**Re:**  
Deep Meadow Mitigation Site  
Monitoring Year 4 Annual Report - FINAL

## DEEP MEADOW MITIGATION SITE

DMS Project No. 97131  
NC DEQ Contract No. 6887  
DWR Certification No. 18-0264  
USACE Action ID No. SAW-2012-01107  
Data Collection Period: January 2023 – November 2023

RE: Deep Meadow Stream and Wetland Mitigation Site – Draft Monitoring Year 4 Report  
Yadkin River Basin – HUC 03040105  
Union County, NC  
DMS Project ID No. 97131  
Contract # 006887

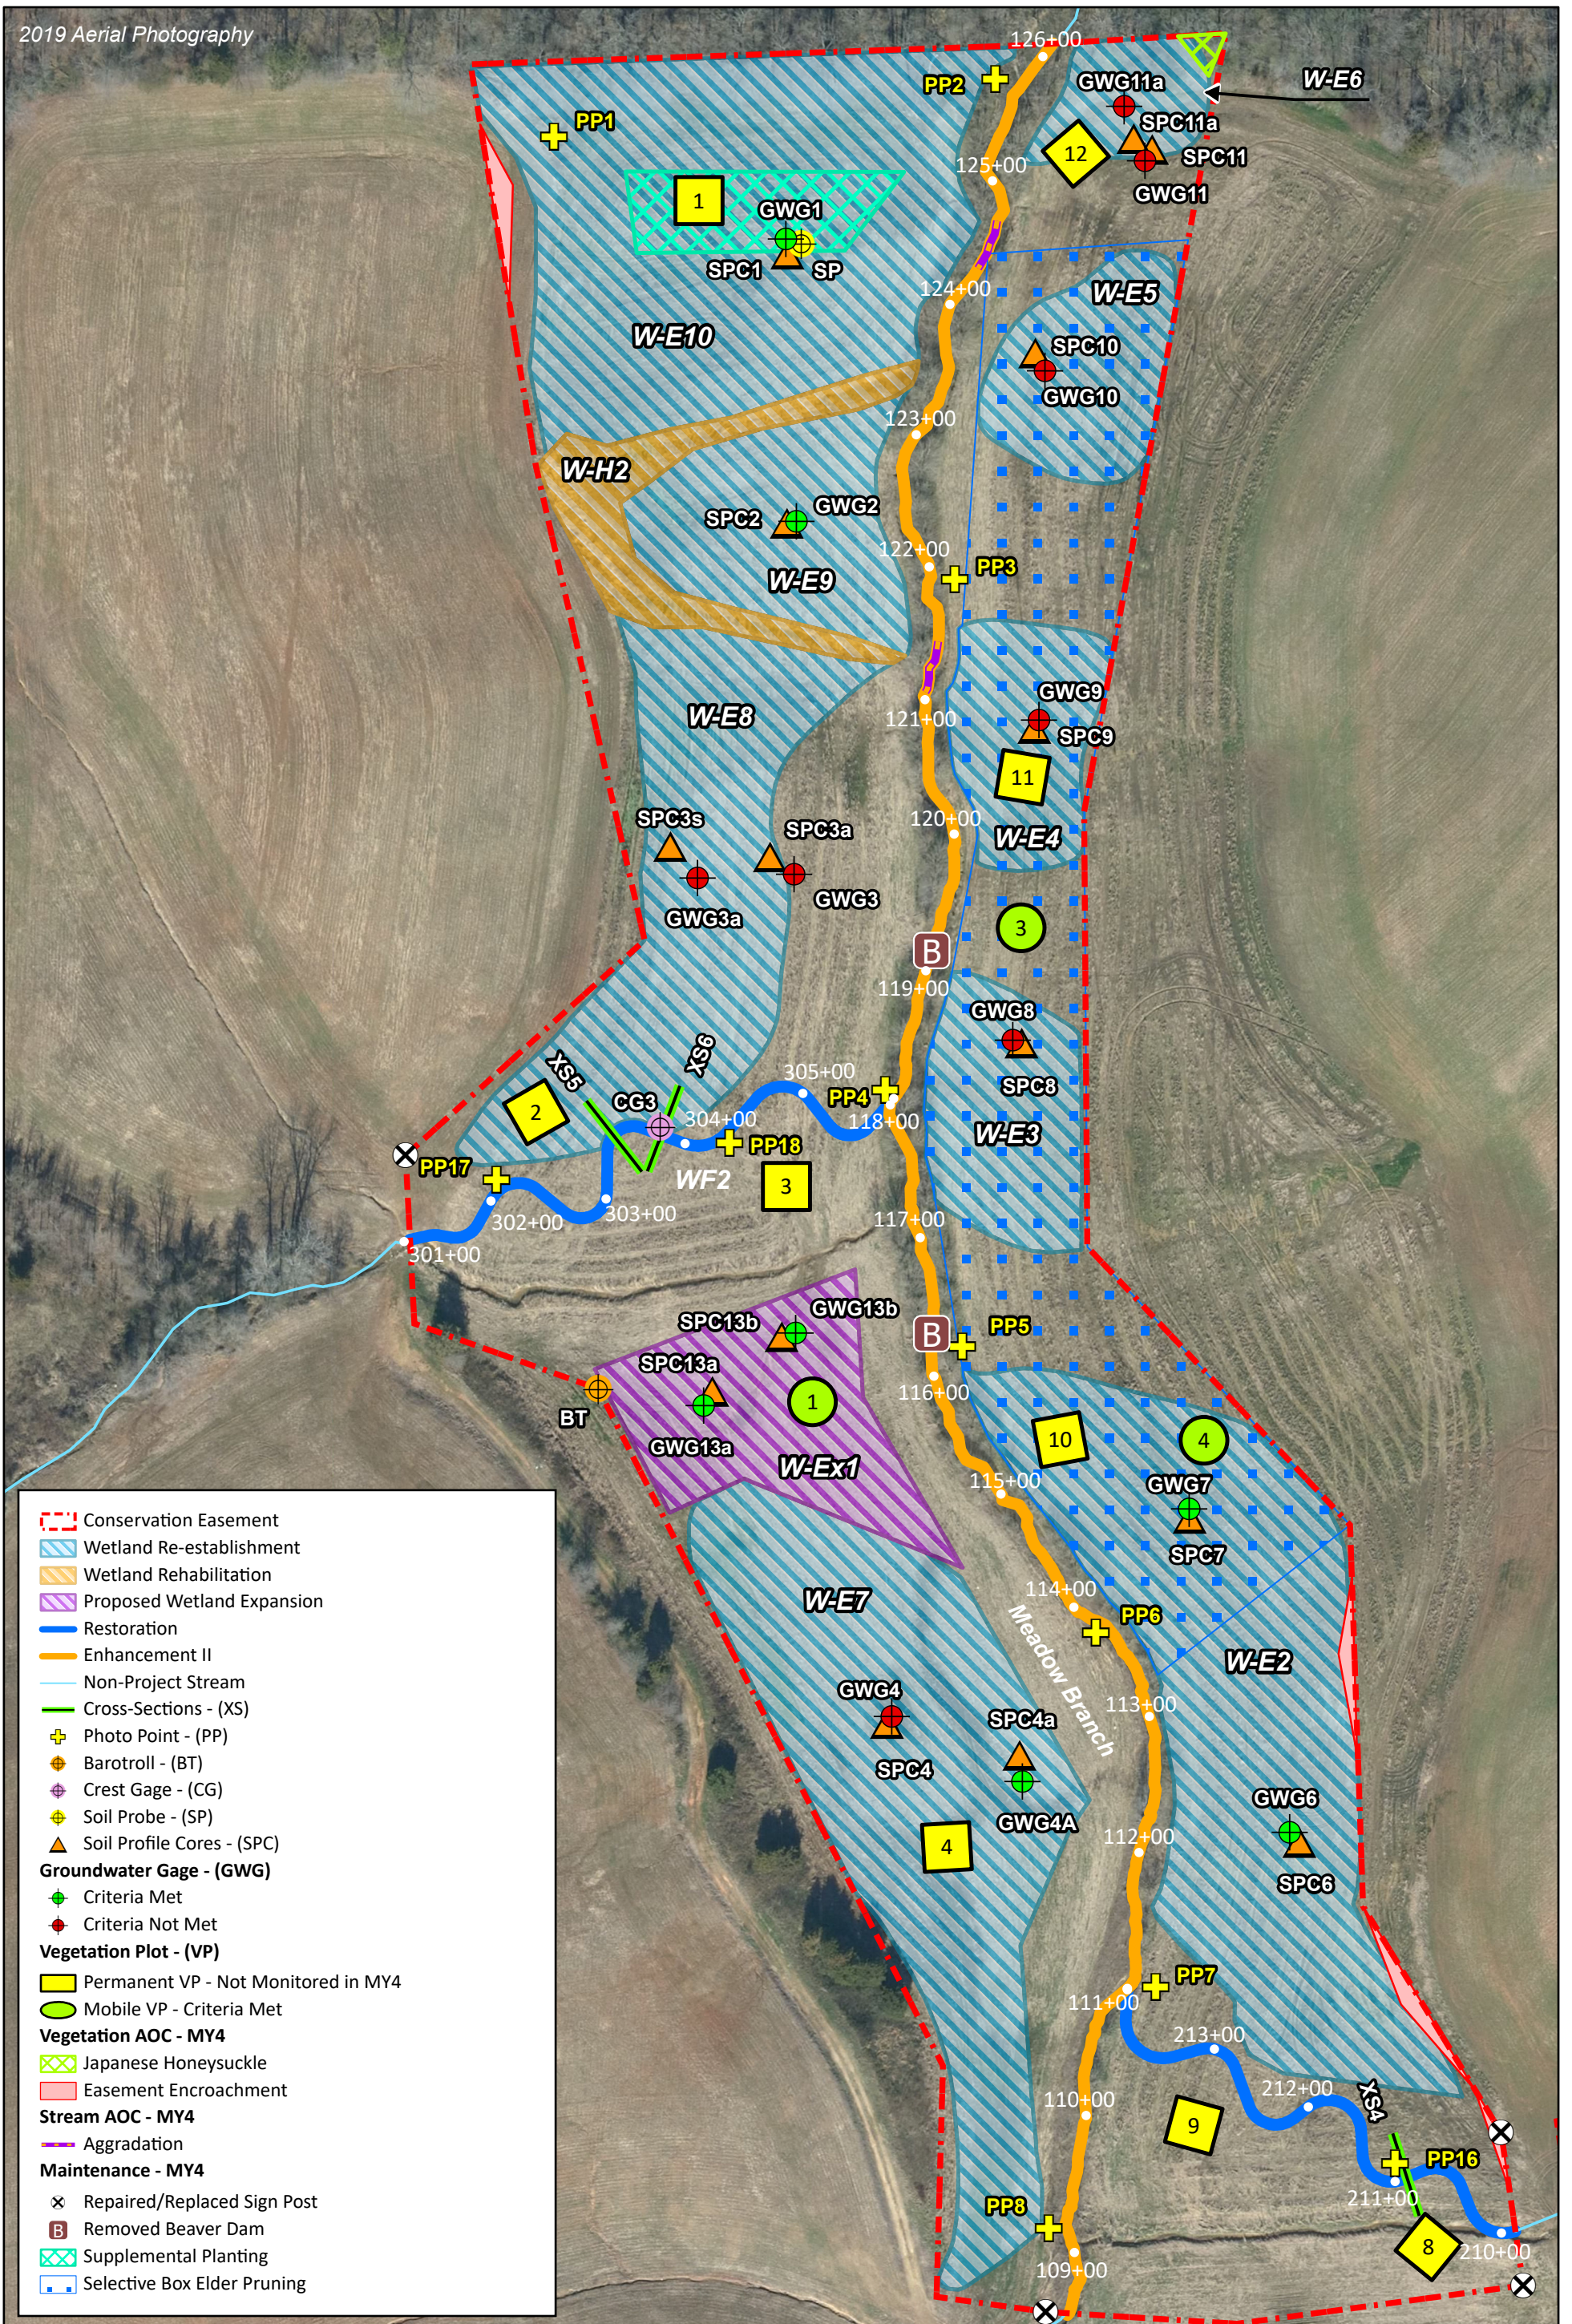
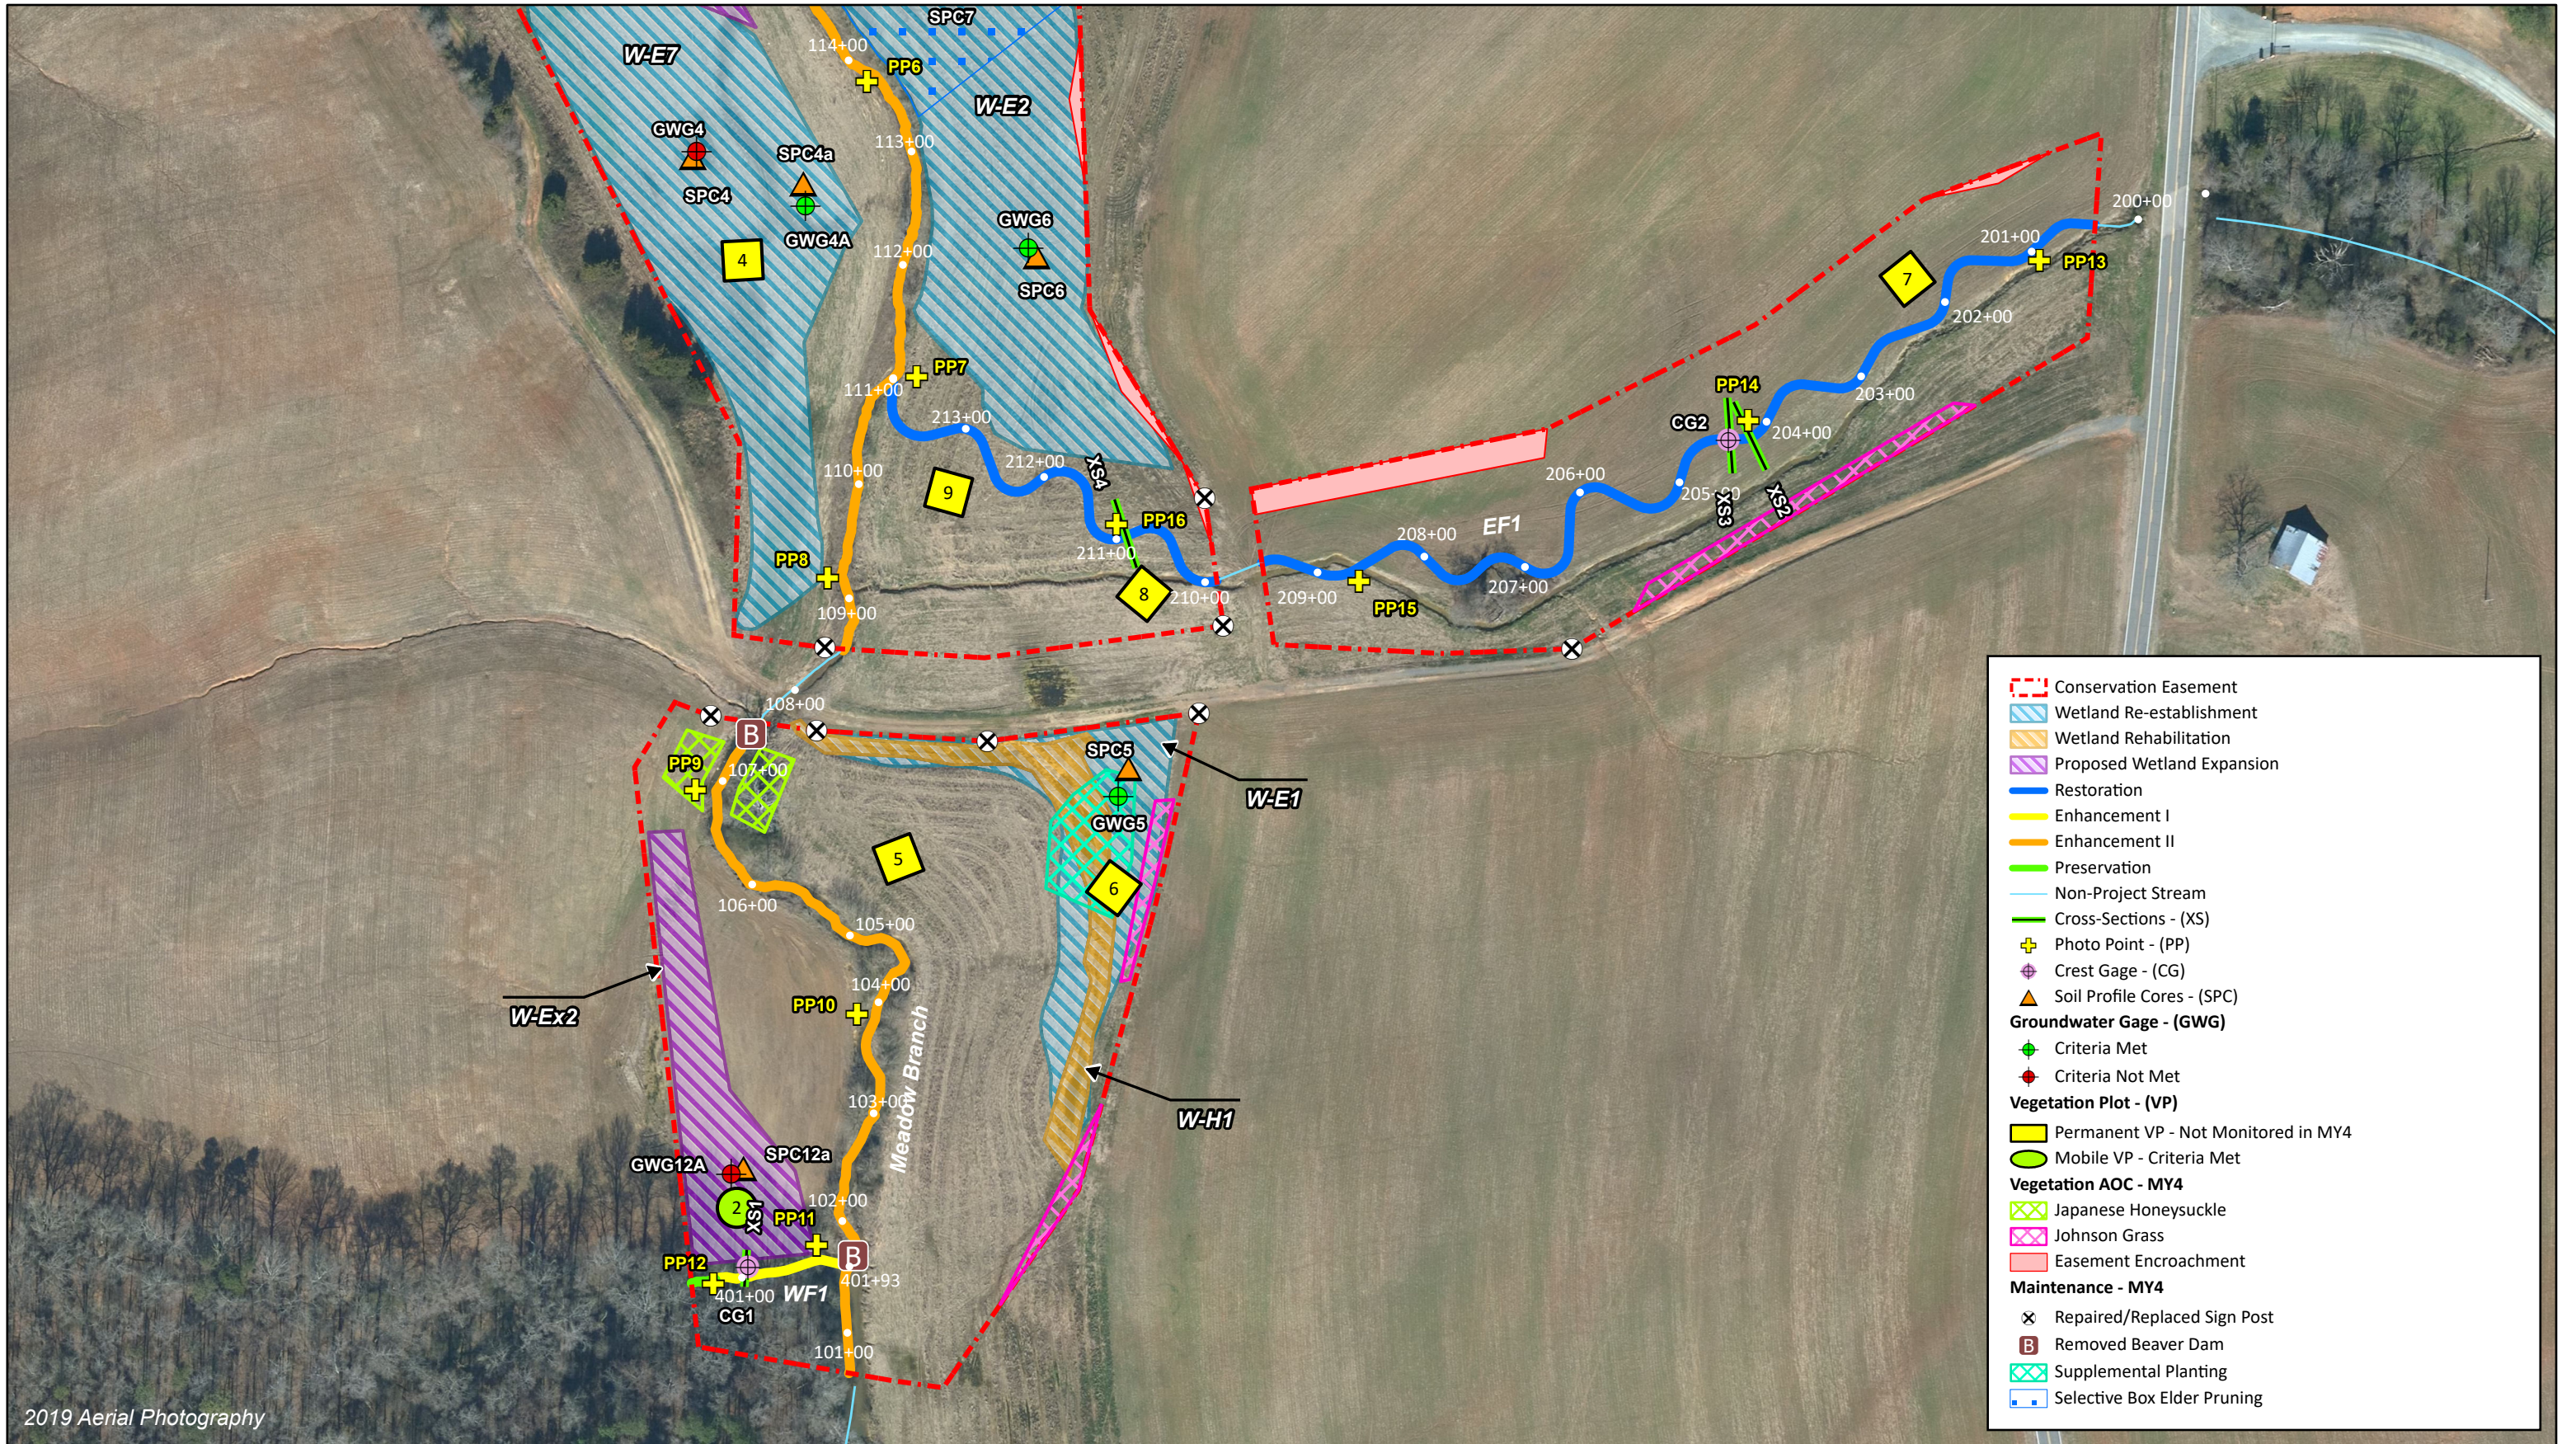
**DMS' Comment: The report mentions that a wetland expansion request is not part of this submittal but will be forthcoming. However additional wetland expansion areas are mapped on the CCPVs. Does Wildlands have a timeline for a more formal request?**

*Wildlands' Response: As stated in Section 1.4.7 and prior to a formal request for approval, Wildlands plans to reassess the Site prior to the onset of the growing season (March 1, 2024) for MY5 to see if there are any additional areas that can be added to the wetland expansion areas. If additional areas are found and additional hydrologic monitoring of the proposed areas is needed, Wildlands will also install the monitoring wells at that time. Once the investigation is complete, Wildlands will submit a request for the approval of all the expansion areas proposed. It is anticipated that this request will be submitted to DMS for review in April 2024.*

**Meadow Branch, station 121+15** – In-stream vegetation and associated aggradation (9/29/2023)

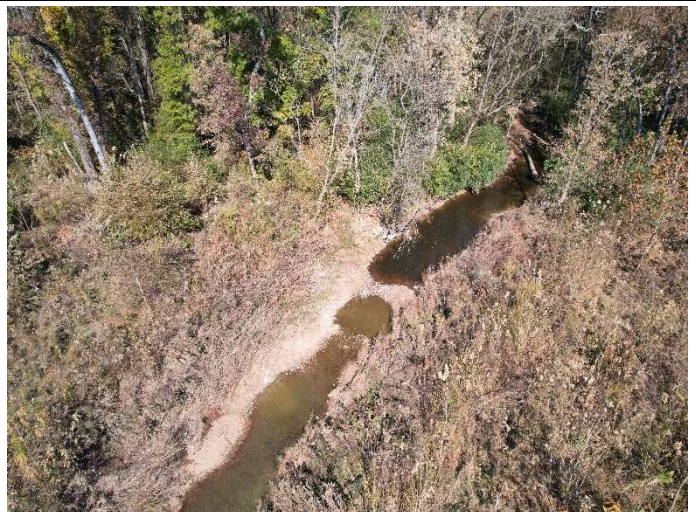
**DMS' Comment: Beaver dams and associated aggradation are noted in the report, and photos provided; however, the visual assessment tables indicate 0% aggradation across the site. Please clarify or update the tables.**

*Wildlands' Response: Beaver dams and areas of aggradation are located on Meadow Branch, which consists of Enhancement II level mitigation. The visual assessment tables are only required for restored reaches.*
